Spent Fuel Pool Seismic Evaluations

NRC Meeting on Recommendation 2.1
October 21, 2015

Typical Section of a BWR Refueling Canal

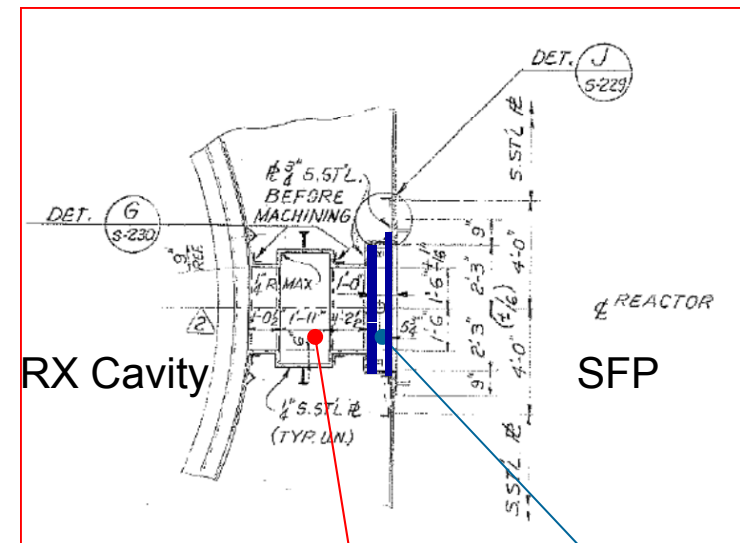
- Minor clarifications are needed relating to (a) use of concrete blocks in refueling gate installation and (b) assumption regarding limited losses to adjacent cavities

- Paper will clarify use of concrete blocks (plugs), which in some cases are installed for shielding purposes
- Paper will clarify assumptions pertaining to characterization of adjacent cavities in BWR (MI, MII, MIII) and PWR designs

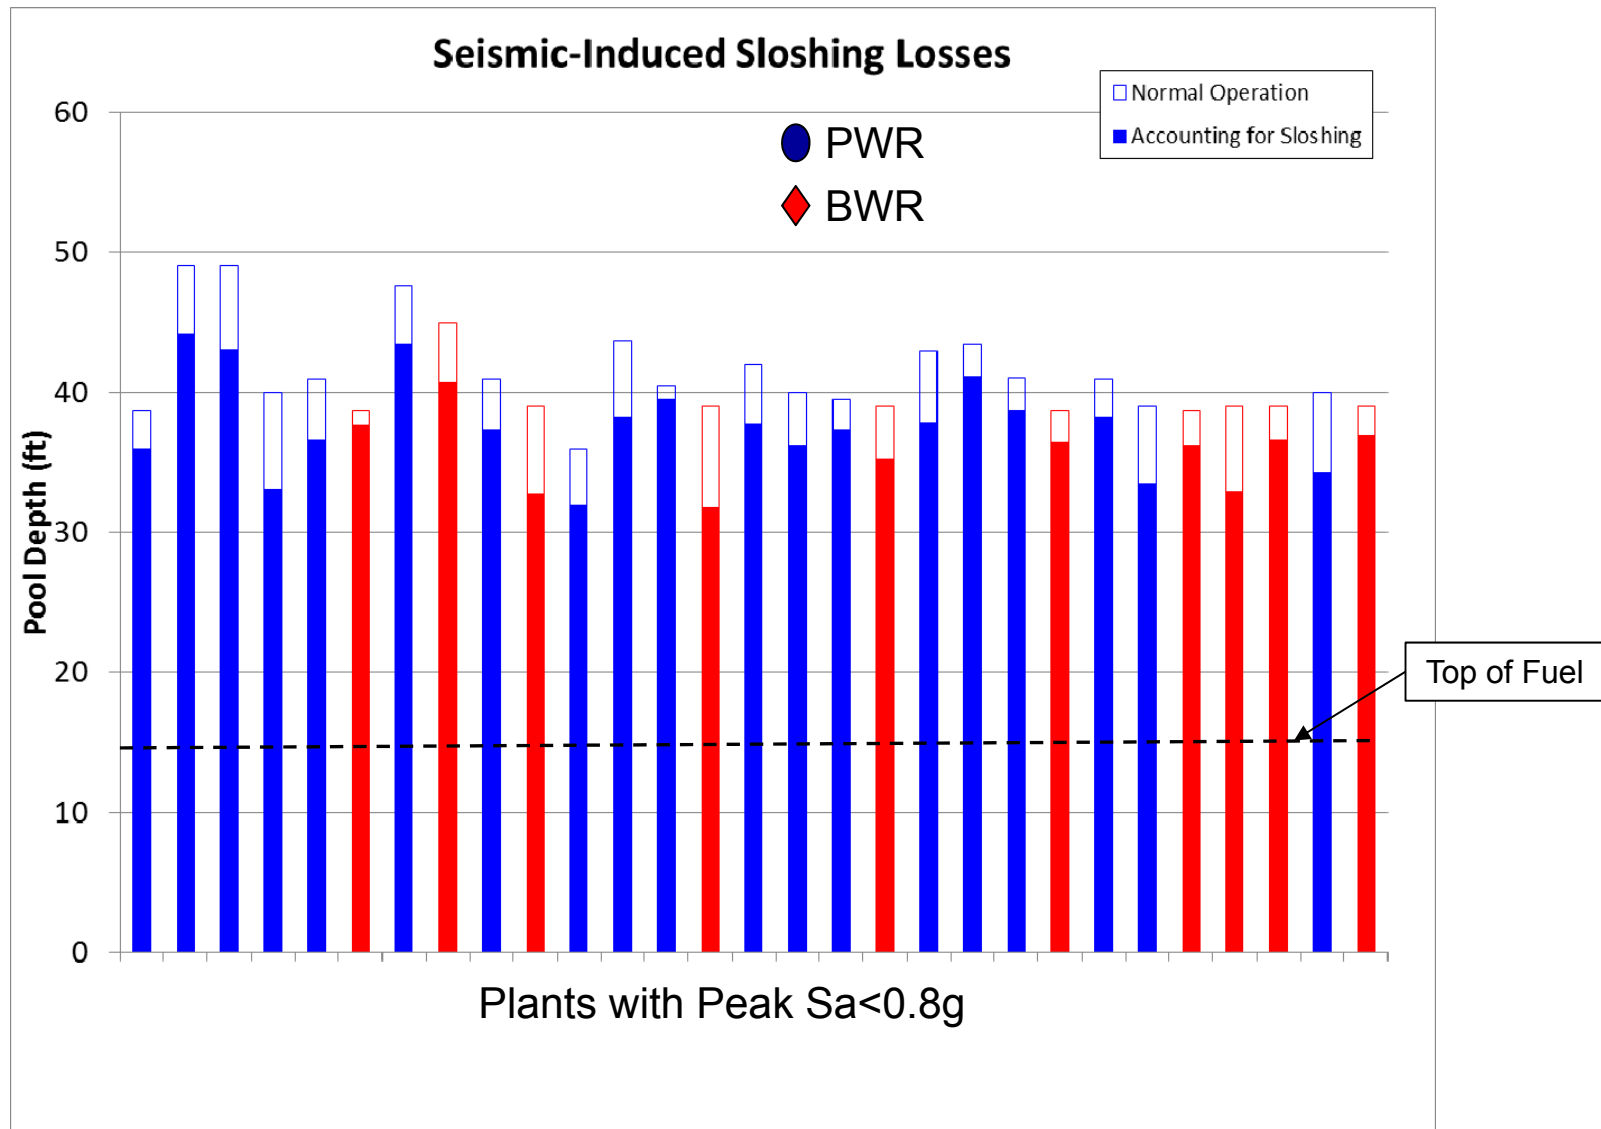
- Median value approach for evaluating SFP water loss due to sloshing does not acceptably represent the plant-specific potential for water loss.

- Industry survey of SFP geometry and SPID approach will be used to calculate sloshing losses on a plant-specific basis
- The SPID approach is judged to be conservative
- GMRS demands will be considered
- The paper will be revised to describe the results and conclusions
- Distribution of results rather than median results will be presented

Comparison of NUREG 1738 and Plant Heat Loads

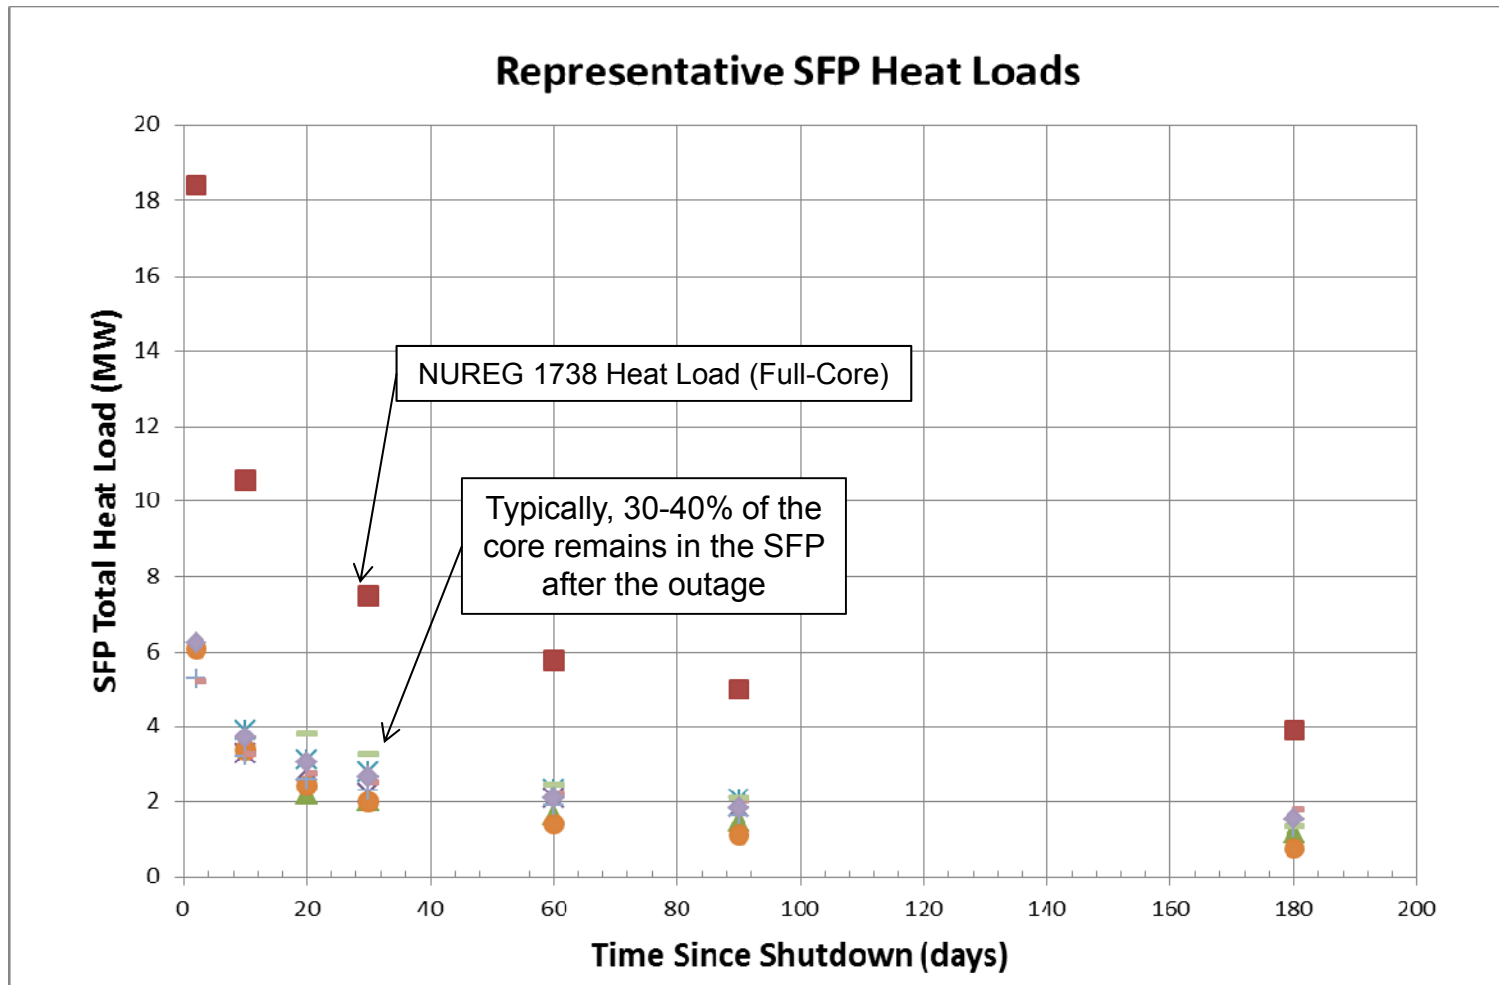
- Should be confirmed that the NUREG-1738 approach does not underestimate the amount of evaporative SFP water loss and expand basis for assumed spent fuel pool heat loads.

- The NUREG-1738 approach was referenced in the paper due to the inherent conservatism in SFP heat loads (e.g. small pool with a full-core off-load)
- Shift to a more realistic approach, where plant-specific heat-up and evaporation calculations have been performed
- Inputs will be based on realistic plant geometry and heat loading
- Calculation methods will be consistent with the SPID (Appendix EE to EPRI Report 1025295)
- Paper will be revised to include results of plant-specific evaporation calculations and bases for assumed heat loads
